Current Zoning: MUDD(CD) (mixed use development, conditional)  
Proposed Zoning: MUDD(CD) SPA (mixed use development, conditional, site plan amendment)

Approximately 0.43 acres located on the west side of Park Road and north side of Drexel Place.

The petition proposes to modify an approved plan to allow any office or retail use allowed in the MUDD zoning district. The site is currently developed with an office building and a single-family home.

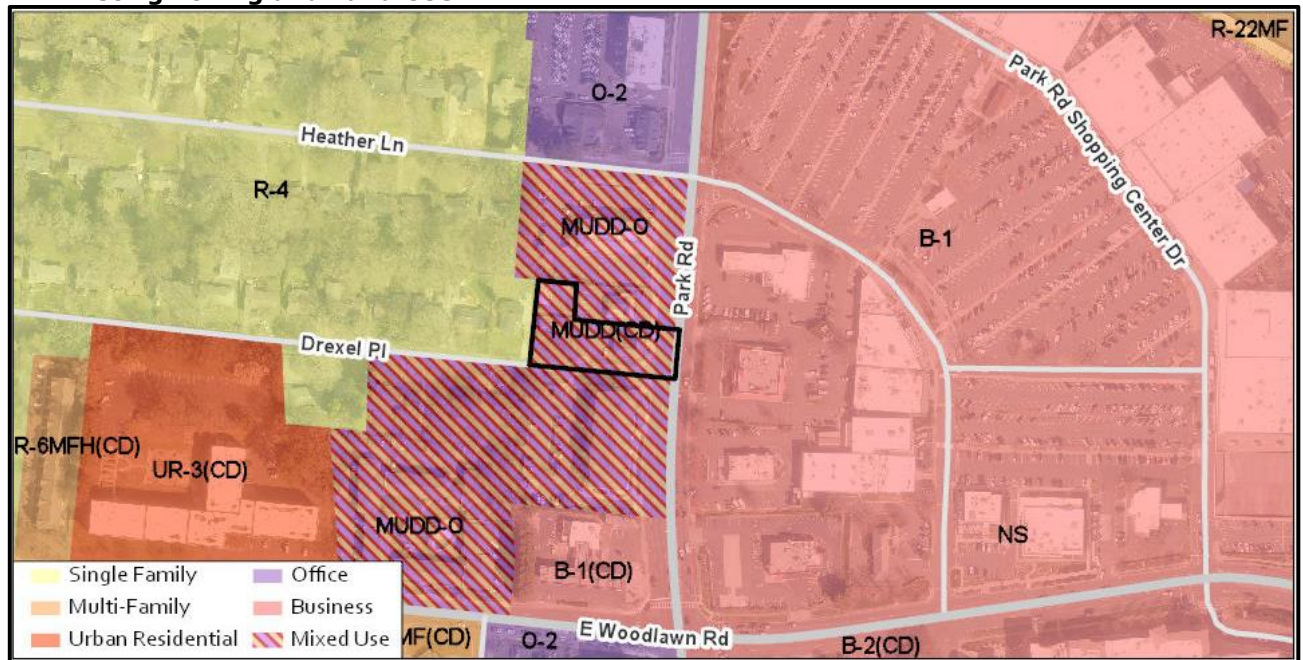
1. Park Road is a major thoroughfare inside Route 4 with a future right-of-way of 80 feet as identified in the Council adopted Comprehensive Transportation Plan and CRTPO. The petitioner should revise the site plan and conditional notes committing to the dedication of right-of-way, fee simple, of 40 feet from centerline of the road to meet minimum requirements.

2. Add a conditional note stating the commitment to building the streetscape on Park Road and Drexel Place as generally depicted in the rezoning plan.
3. Add a conditional note stating the commitment to dedicating the right-of-way on Park Road.
